**Pacific Gas and Electric Company's (PG&E's) 2016
Energy Storage Request for Offers ("RFO")
Frequently Asked Questions**

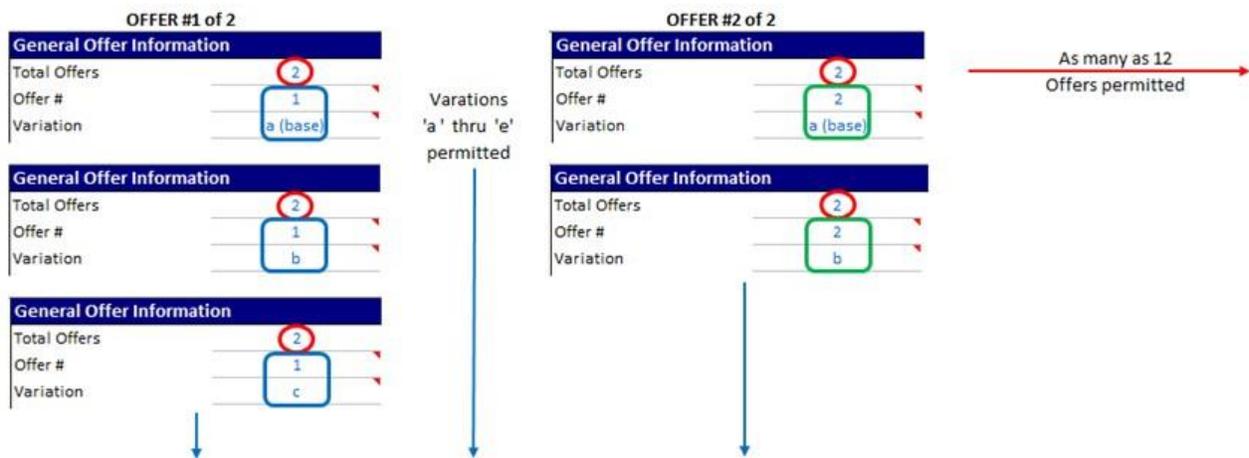
1. Could PG&E clarify the difference between offers and variations, and how to number/letter them?

Participants may submit up to twelve (12) Offers. Changes in a Project's location, technology, or specific agreement type (e.g., CSA or PSA) would result in a new Offer. Participants may submit up to ten (10) variations. If a Project's location, technology, or specific agreement type remain constant, then changes in other characteristics such as delivery term, price, commercial operation date, capacity, or duration would constitute a unique variation.

Example: Offer Form screenshots for two Offers are illustrated below. The first Offer (PSA) has 3 variations, a → c. The second Offer (CSA) has two variations, a → b. In the illustration below there would be five (5) Offer Form workbooks submitted, for the five (5) unique variations. Each Offer should submit a complete Offer package of applicable appendices. PSA packages should not include CSA information and vice versa.
